Dendrobium Area 3C – Longwall 21A – SMP Variation

However, in order to avoid an intrusive sill that was found at the approved commencing end of Longwall 21A, a revised longwall start position 28 m to the east of the approved start position has been developed. As such, Illawarra Coal Holdings Pty Ltd (ICHPL) request that the Department approve a variation to the Longwall 21A SMP Approval to account for this small change.

The effects of the proposed modified commencing end of Longwall 21A
on previous subsidence predictions and impact assessments

Figure 2-1

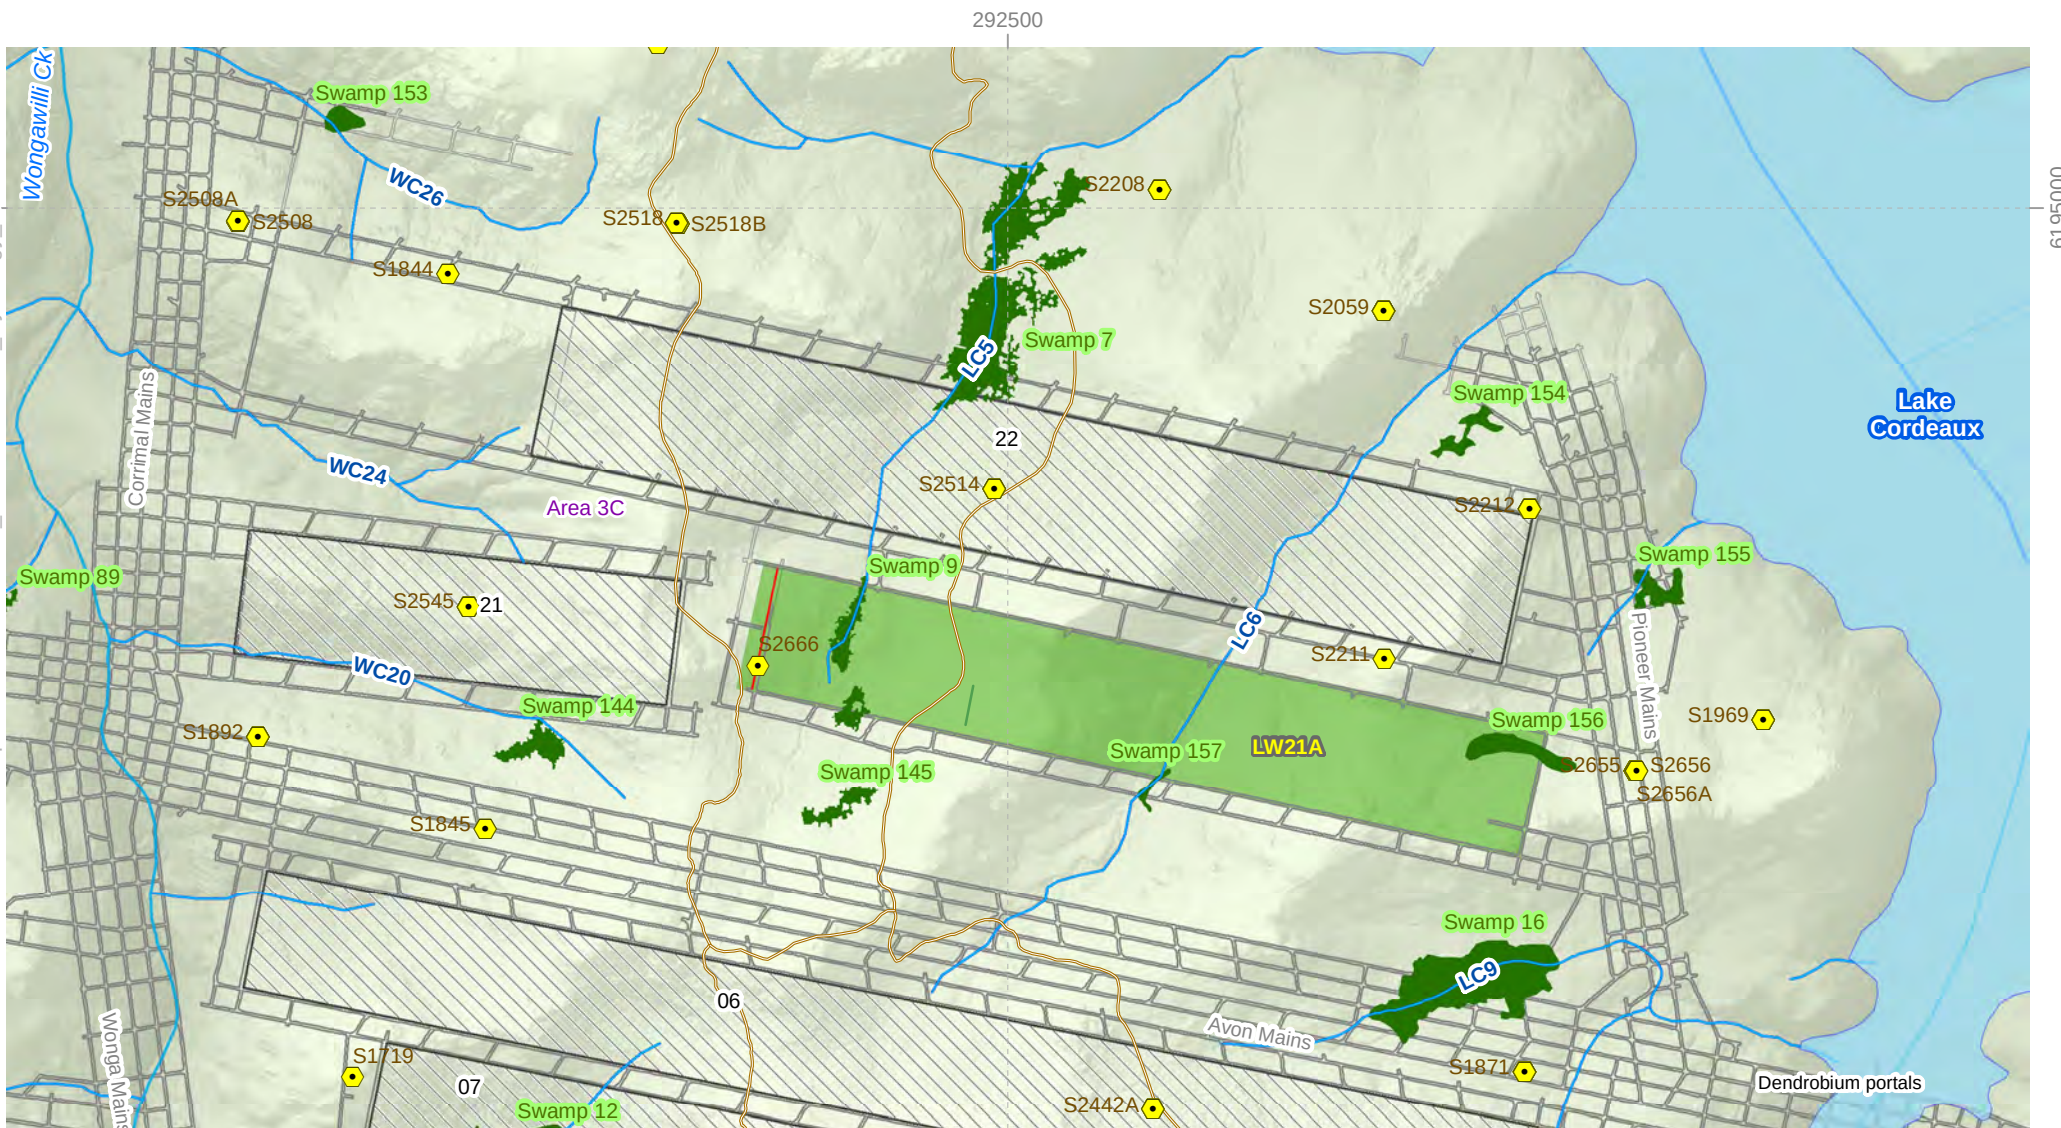
Figure 2-1 shows that none of the swamps are close to the starting end of the panel, and so none will be affected by the change in position (i.e. no change to the effects at these swamps, including Swamp 9 which is closest to the starting position). Swamps within the footprint, and outside the footprint to approximately 120 m are expected to show rapid change to water table behaviour once mine under.

Figure 2-1 indicates that two tributaries flow over the footprint of Longwall 21A: LC6 (in the middle of the longwall), and LC5 commences at Swamp 9 near the western end of the panel. LC5 is still 135 m inside the proposed starting end (compared to approximately 160 m for the approved mine plan). As such, there might be some very minor reduction in surface cracking effects, but in reality, no change to the occurrence of surface cracking at LC5 (or LC6) is expected as a result of the variation to the mine plan.

Figure 2-1 shows watercourse and tributaries around Longwall 21A. As noted above, the variation to the mine plan only marginally changes the distance from the edge of the panel to LC5, and the same length of LC5 remains above the footprint of Longwall 21A. As such, no changes to baseflow losses (or increased leakage) are expected.
